Hudson Clinic
1400 Hudson Street
Elkhart, Indiana 46516

01. Hudson Clinic Accessible Parking

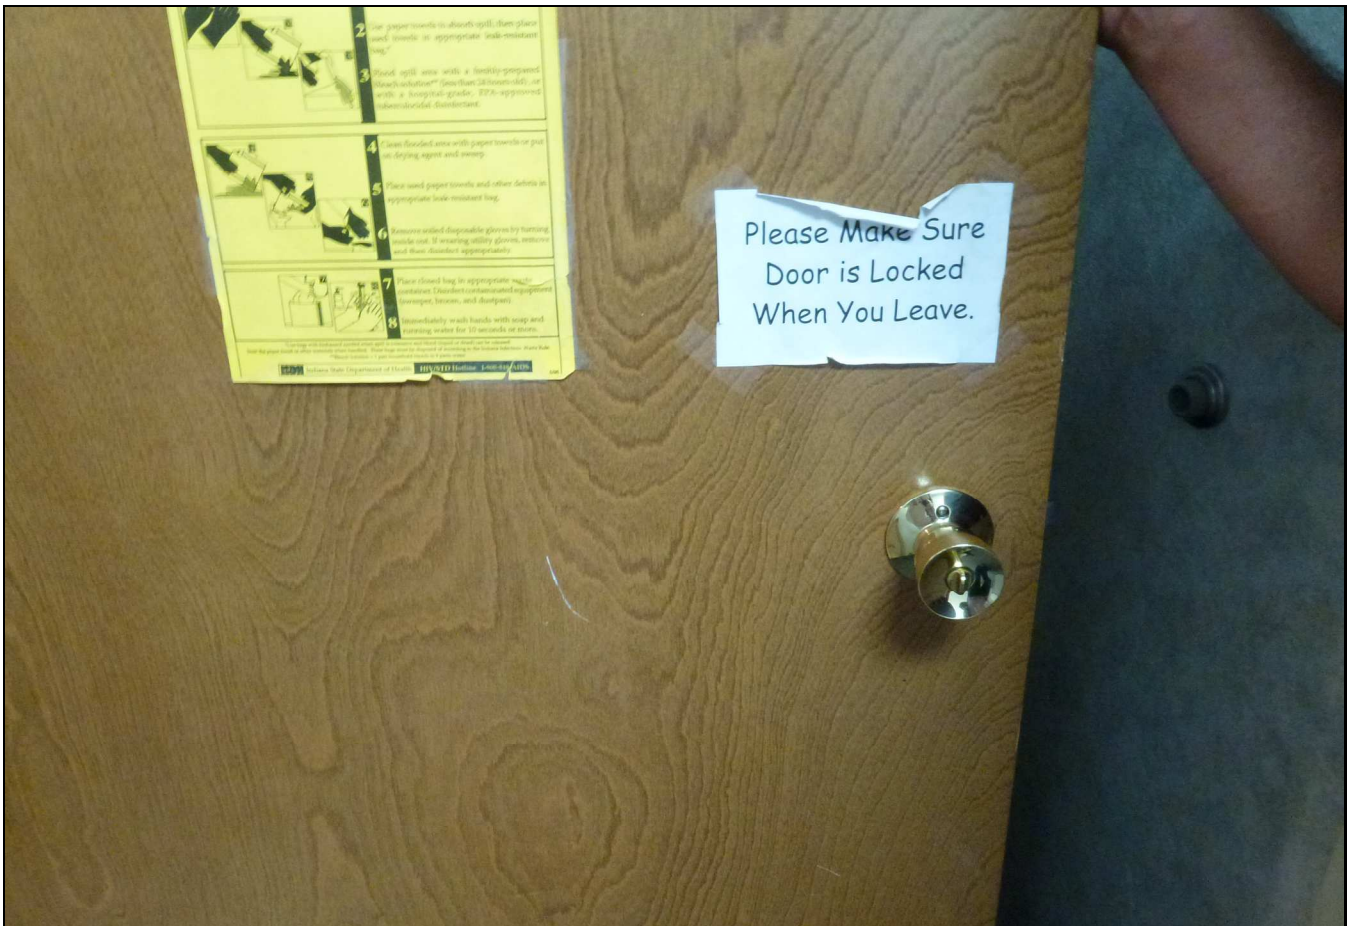
1. Parking	1	No "Van Accessible" sign at van accessible parking space. No enforcement procedure for accessible parking	4.6.4	ADAAG requires accessible parking spaces to be located in each parking lot. Accessible parking spaces are required to have upright signage that includes the symbol of a accessibility and van accessible signage where required. Add one "Van Accessible" sign. Enforce parking regulations.	L: Space is adequate for vans, just no sign posted.	\$50	Elkhart County General Fund	Van Accessible sign installed		2014

05. Hudson Clinic Accessible Restroom

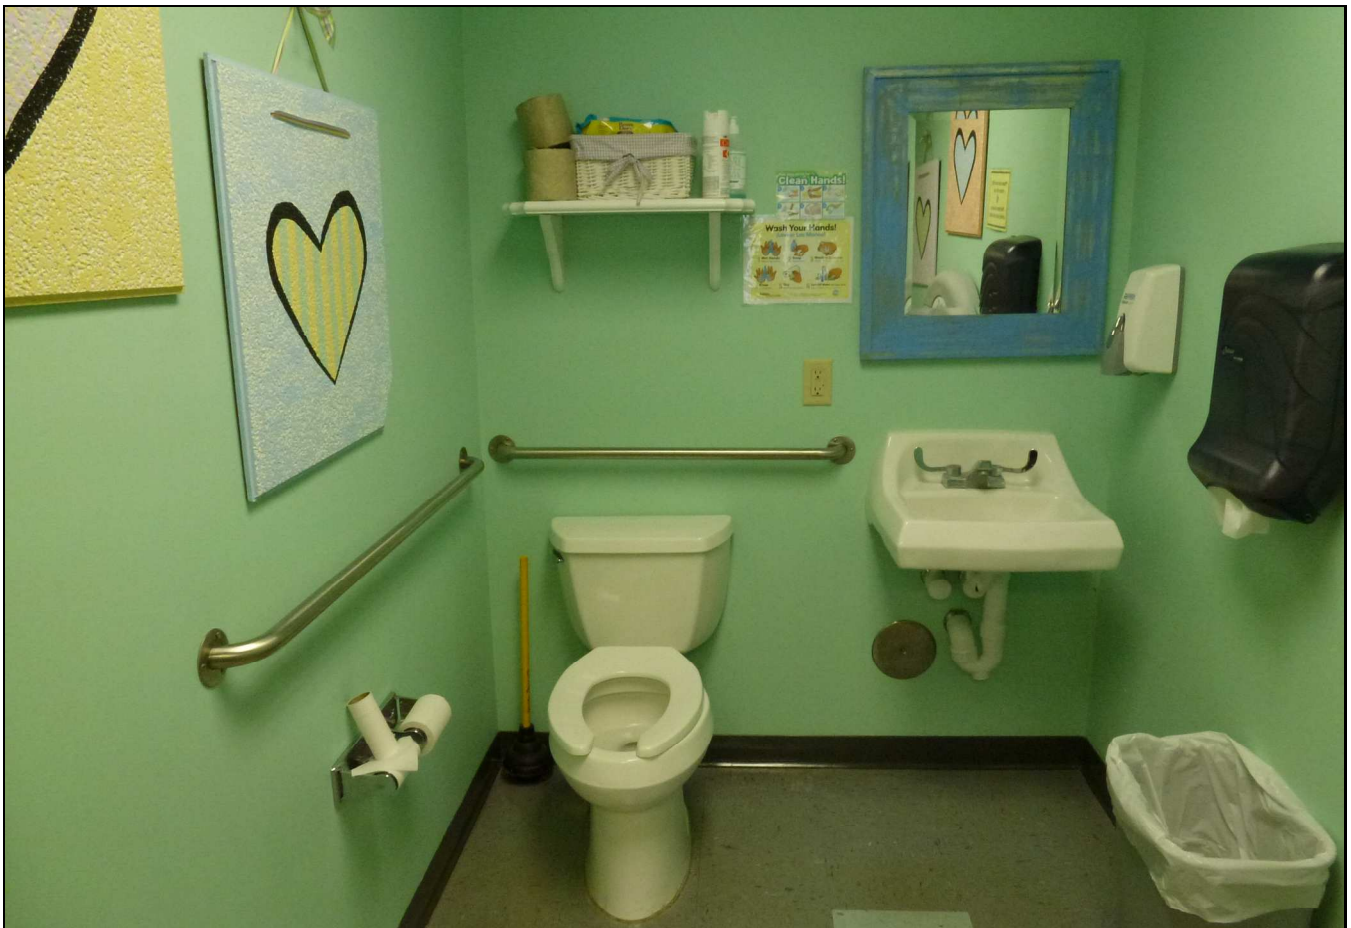
4. Rest room	5	Lavatory apron exceeds the minimum height. Unit is 28" from floor. (Rest room in dental area meets requirement)	4.19.2	ADAAG requires lavatories to be mounted with the rim or counter surface no higher than 34in above thenished floor and to provide a clearance of at least 29: above teh finish floor to the bottom of the apron. Raise the lavatory to provide 29" to finish floor.	L: Pipes and plumbing may need adjusted for 1".	\$500	Elkhart County General Fund	New lavatory		Jan-15

5. Rest room	5	Accessible rest room only has one grab bar near the toilet.	4.17.6	ADAAG requires grab bars to be mounted next to and behind the toilet. Install a grab bar behind the toilet.	M: This is an inexpensive easy fix that will provide considerable help.	\$400	Elkhart County General Fund	Grab bar installed		Jan-15

6. Rest Rooms	5, 6	Mirror's mount height exceeds the maximum requirement. The mirror is mounted at 51" from finished floor.	4.19.6	ADAAG requires mirrors to be mounted with the bottom edge of the reflecting surface no higher than 40" above finished floor. Lower the mirrors.	M: This could be easily adjusted.	\$50	Elkhart County General Fund	Mirrors lowered		Jan-15
